SPECIALIST COMMENTS RESPONSE – RANGITOOPUNI PROJECT – (COUNCIL REFERENCE BUN60449727)

Further to your recent instructions, we have reviewed the comments received from Auckland Council, Auckland Transport and NZTA on 18 September 2025 and have responded to the transport matters raised.

Figure 16: Deacon Road / Riverhead Road Intersection

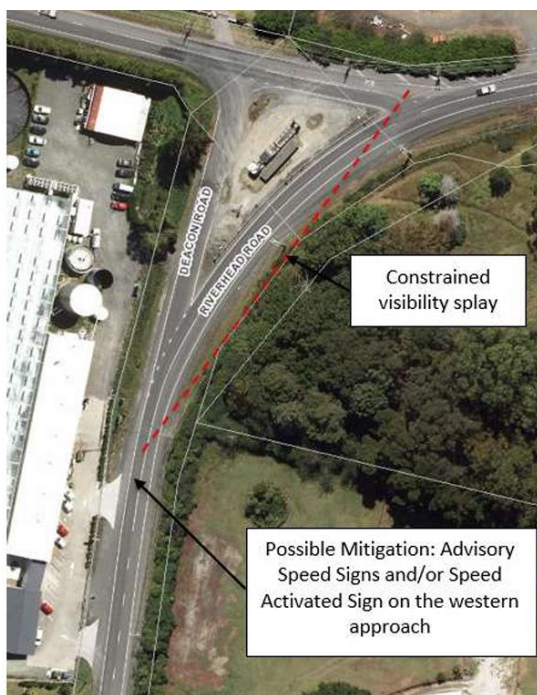
59. The ITA has reviewed the safety record of the Deacons Road / Riverhead Road intersection and identified a crash trend, particularly involving right-turning movements. Visibility from Deacons Road to the west is limited—only about 120m is available versus the 181m required for an 80 km/h design speed. This shortfall is likely contributing to the crash trend.
60. Although the proposed development does not directly affect visibility, it would triple the volume of right-turning traffic from Deacons Road during the AM peak, increasing crash risk exposure. Mitigation measures such as advisory speed signs or speed-activated warning signs on the western approach are recommended to improve safety (refer to Figure 16).

Speed advisory signs are now shown on the engineering plans and put in place on the western approach to mitigate potential safety impacts of the development. As per MOTSAM 1 Section 6 a PW-17 sign consisting of a PW-25 curve advisory speed sign is erected as seen in Figure 17.

Figure 18: Proposed Access 1 Layout with visibility plays highlighted

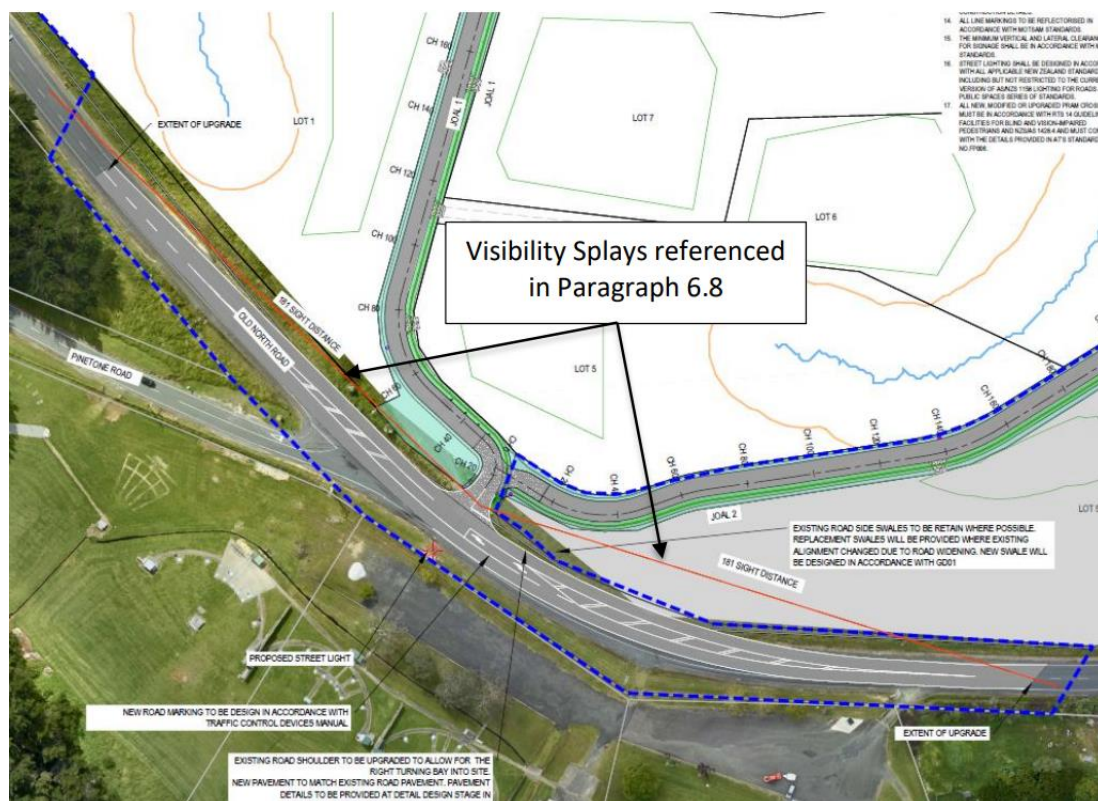
6.8 The visibility plays for the intersection extend over the berms either side of the access. The Scheme Plan drawings indicate that the land to the east of the vehicle crossing would be subject to a land covenant to maintain the sight lines east of the access. This is considered appropriate as vegetation may grow over time that could block the sight lines to the east. To the west of the vehicle crossing, there is a berm and embankment. It is considered that the bank and vegetation would need to be removed or modified to maintain the sight lines. This is highlighted in Figure 18.

6.9 The Scheme Plans show that some of the land along the site frontage either side of the vehicle crossing will be vested. The extent or form of any modifications for this land to create the vehicle access is not clear.

6.10 Vehicle tracking for the vehicle access shows that a 10.3m truck extends slightly into the right turn pocket. The design will need to be adjusted so that the truck will not conflict with a vehicle waiting in the right turn bay. This is a matter of detail that can be addressed at EPA stage.

Figure 20: Deacon Road / Riverhead Road Intersection

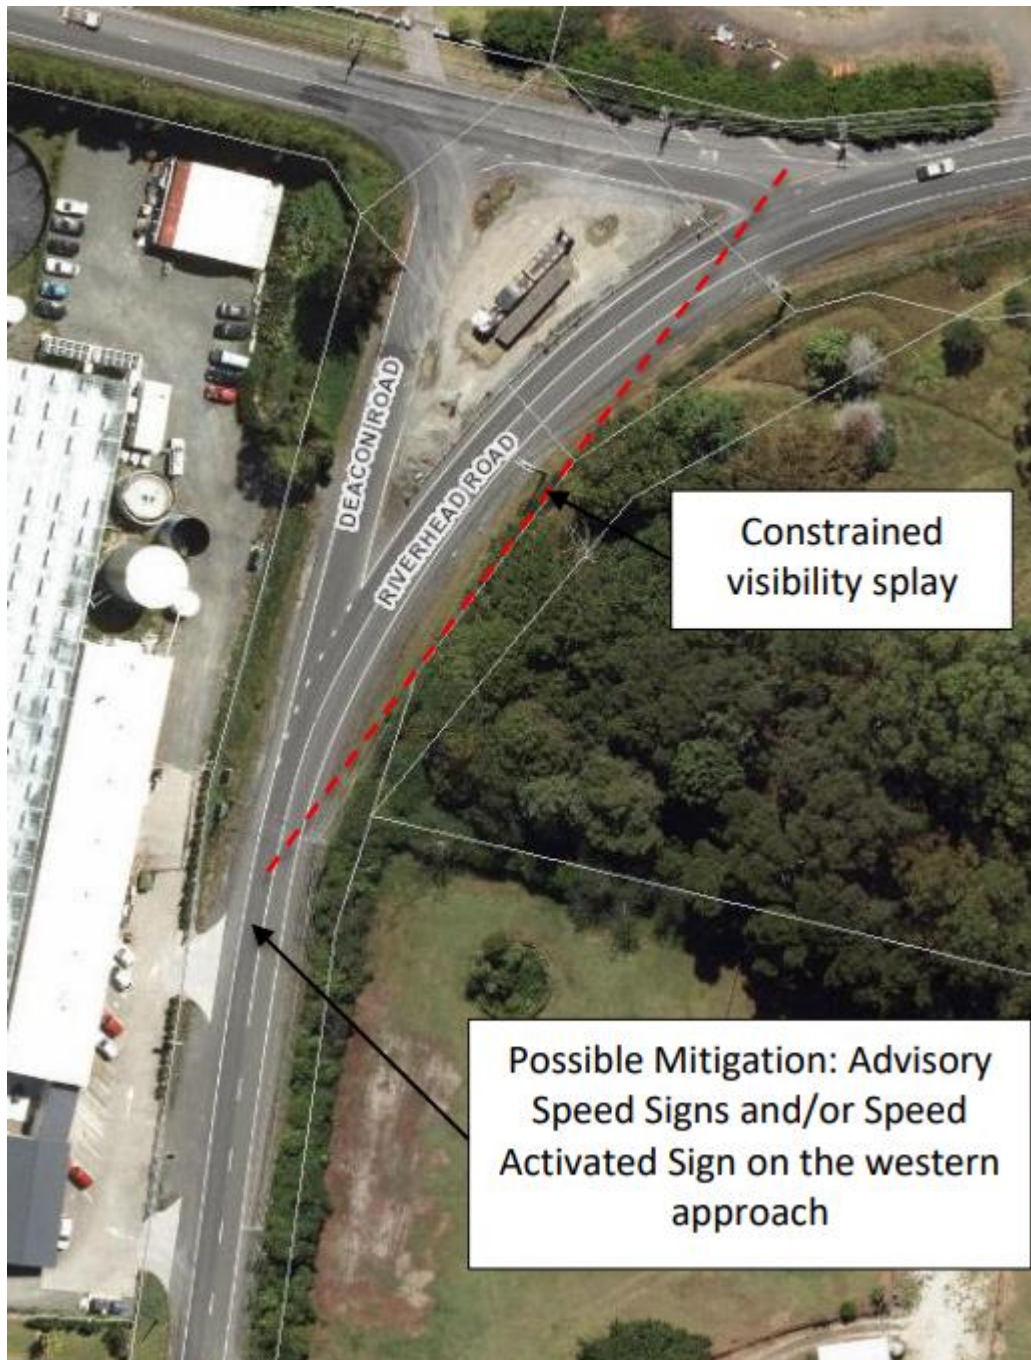
6.33 The ITA identifies that the visibility from Deacon Road to the west along Riverhead Road is limited due to the alignment of Riverhead Road. The deficiency is not reported but from a review of aerial mapping and based on an 80km/h design speed, 181m of visibility is required but only around 120m is available. It appears that this limited visibility could be a contributory factor to the existing crash trend, as there were a number of crashes that involved rightturning movements at this location. Whilst the development itself does not impact on the visibility at the intersection, it does triple the right turn volume from Deacon Road in the AM peak⁸ thereby increasing the crash risk exposure.

6.34 Mitigation measures may be appropriate, such as advisory speed signs or speed-activated warning signs on the western approach to the intersection (refer to Figure 20 in this memo).
